***FC-EE Parameter Negotiation Proposal -
T11 Document 14-107v0***

19-Mar-2014

By: Adrian Butter
asbutter@us.ibm.com

Figure 49 LPI Mode Transmitter State Diagram

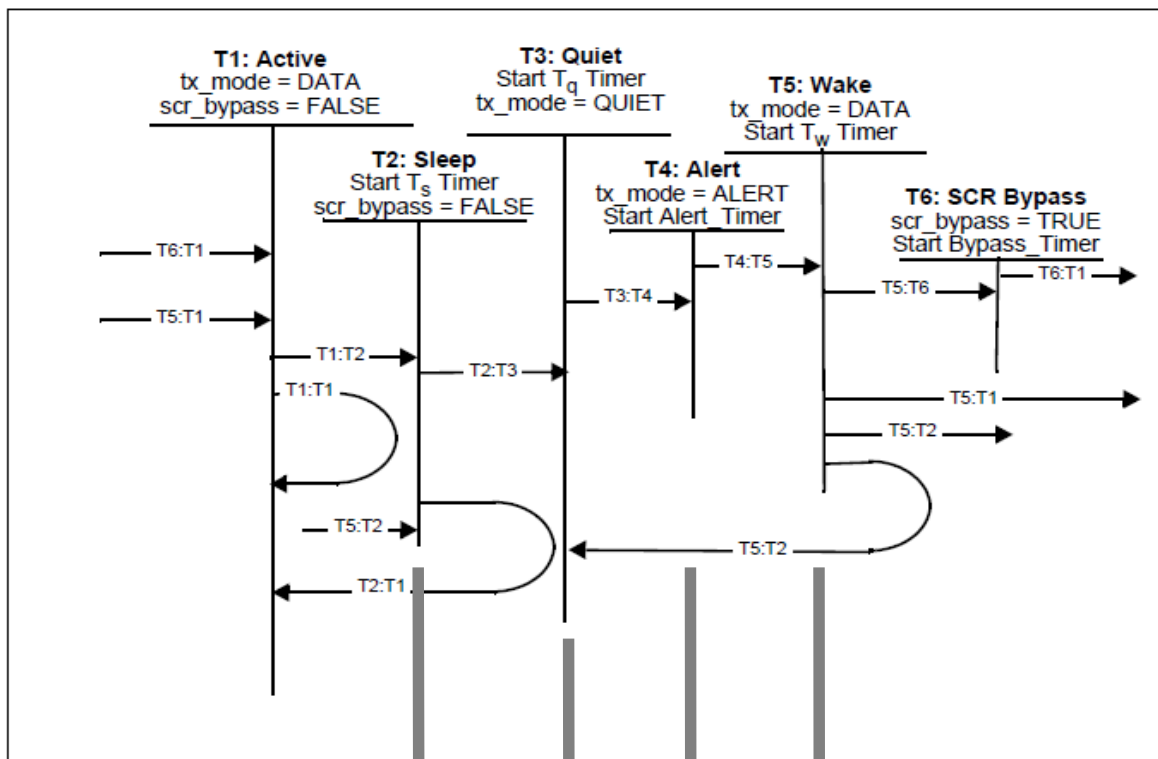
➤ FC-FS-4 Section 10.5 mentions an LPI Mode use case in which the transmitter continually sends LPI...

During the quiet cycle, some transceiver types may not be capable of turning off the transmitter/receiver. In this case, LPI shall be transmitted during the LPI Mode in order to indicate low power operation, this allows the port to turn off unused capabilities to save power.

o However, current LPI Mode Transmitter state diagram does not support this use case...

Figure 50 - LPI Mode Receiver State Diagram

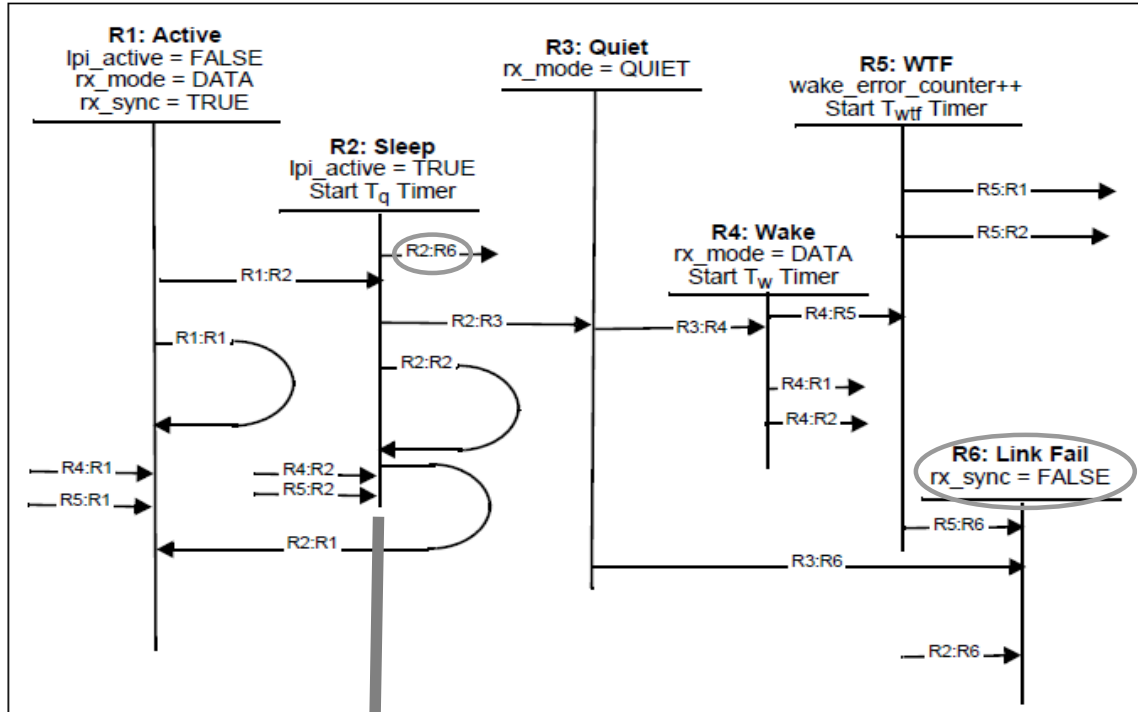
- FC-FS-4 Section 10.5 mentions an LPI Mode use case in which the transmitter continually sends LPI...
 - ... and current LPI Mode Receiver state diagram does not support this use case:

Since transmitter continually sends frames, receiver maintains sync (rx_sync=TRUE) throughout R2:SLEEP:

If all frames are LPI, then only R2:R6 applies after Tq expires...

Figure 49 - LPI Mode Transmitter State Diagram

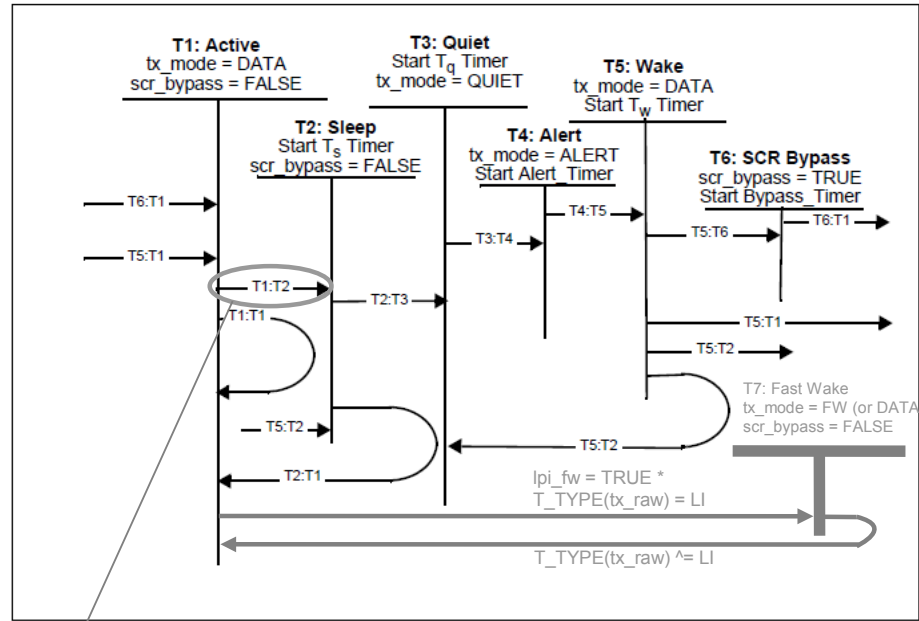
- Proposed updates to FC-FS-4 to support the LPI Mode use case in which the transmitter continually sends LPI:
 - Define Transmitter and Receiver "Fast Wake" states (similar to 802.3bj Figure 82-16 & 82-17)

NOTE: Must also check for lpi_fw = FALSE to make T1:T2 transition...

Figure 50 - LPI Mode Receiver State Diagram

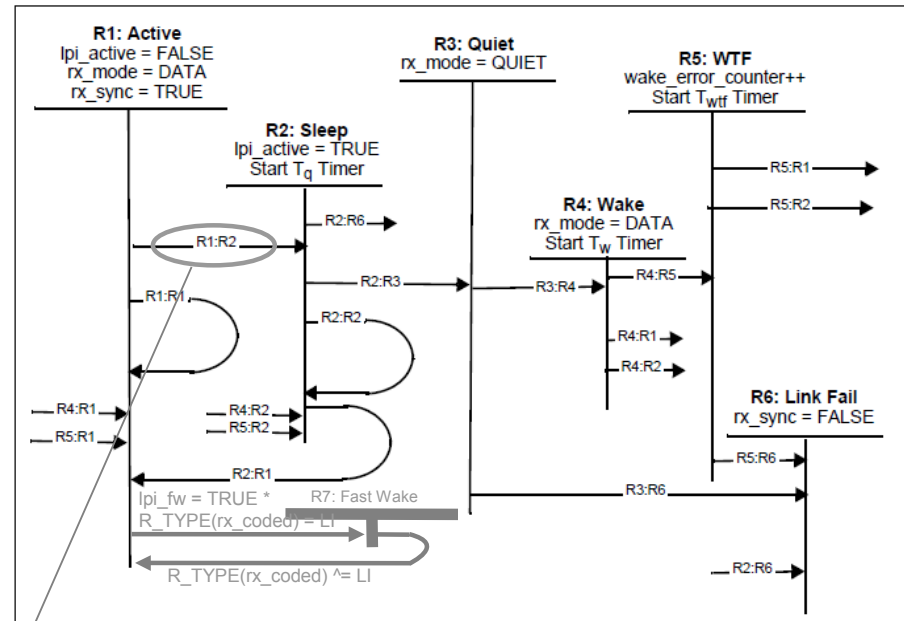
NOTE: Must also check for lpi_fw = FALSE to make R1:R2 transition...

Figure 82-17—LPI Receive state diagram

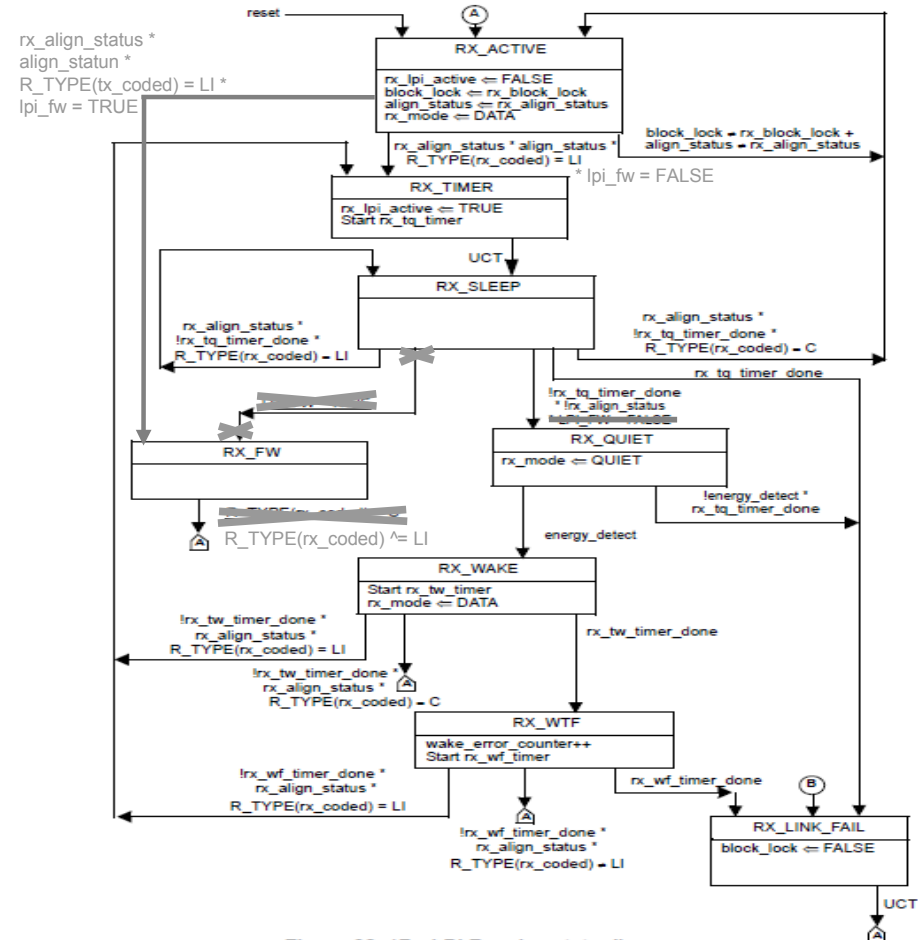
- FC-FS-4 provides inadequate detail for FC-EE support @ 128G
- Proposed starting point for specifying FC-EE support @ 128G are LPI Mode state diagrams in 802.3bj Clause 82:

o Note proposed changes to LPI Receive state diagram RX_FW state for 128G FC-EE...
